Amoco 20N-33E-See 12

10/17/83

T 20 N R 33 E State Harding
or County

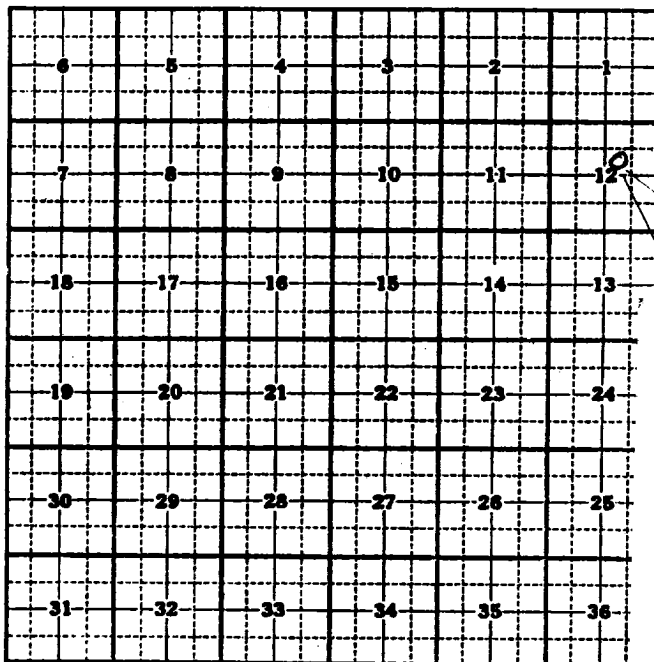
*Amoco production well -
bad cement job. No cement
above or below Glorita*

T 19 N R 34 E State Union
or County

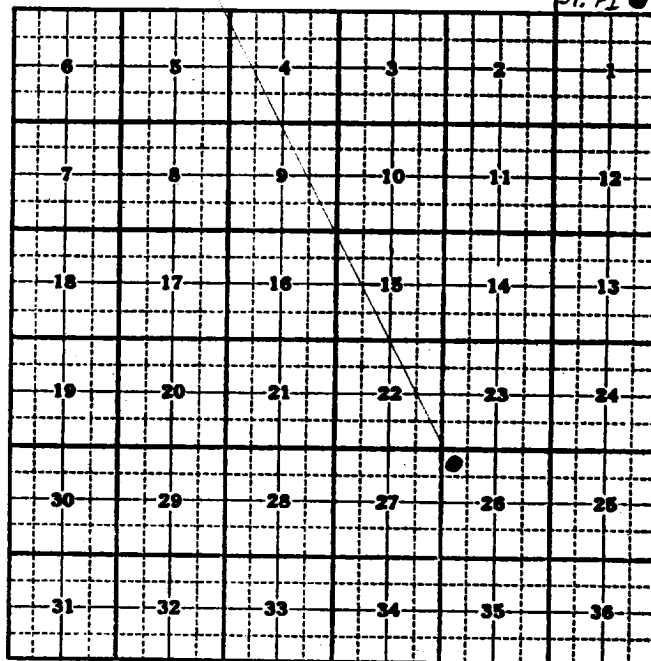
*Amoco disposal well -
in Glorita.*

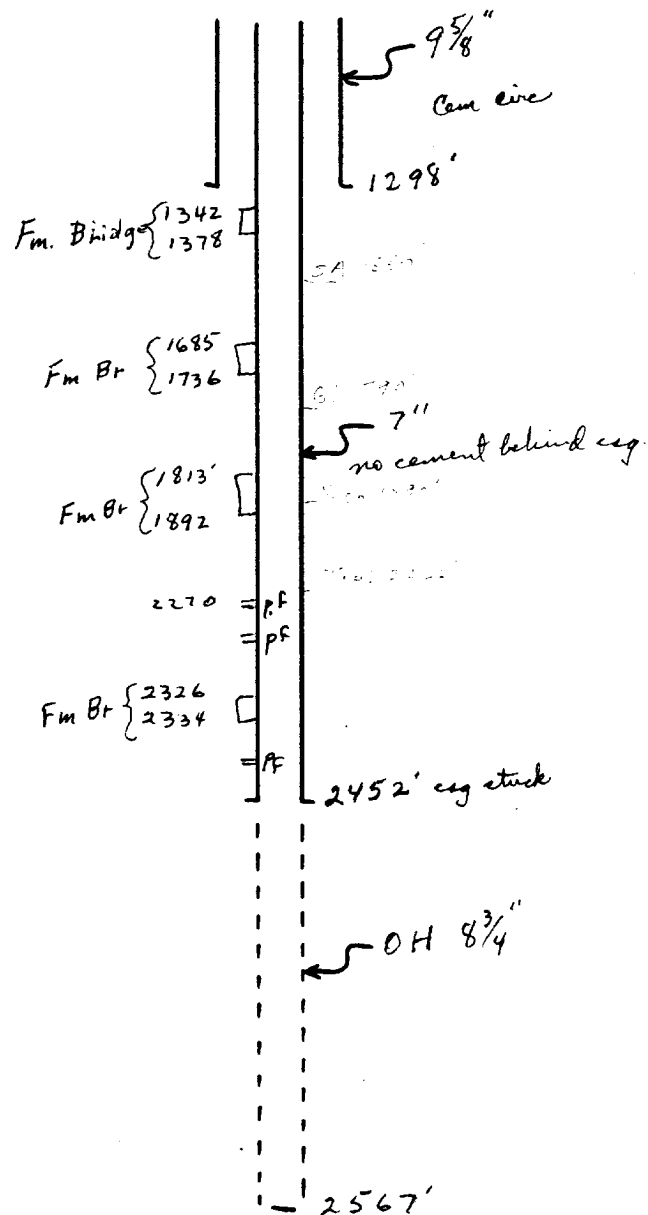
I have been puzzling over this deal -
have looked at all logs. It is a very strange
situation of unusual casing, poor cement on prod. cas.
etc. The squeeze cementing is obviously for
isolation of Tubb.

My concern is, what might happen when
massive injection into the Glorieta begins (with
full scale production). Could pressures at Sec 12,
20N-33E increase the normal 200-300 psi Glorieta
to a point that fluids from that zone might move
up (and maybe down) outside of casing?

Think this is too far away to
be any problem.
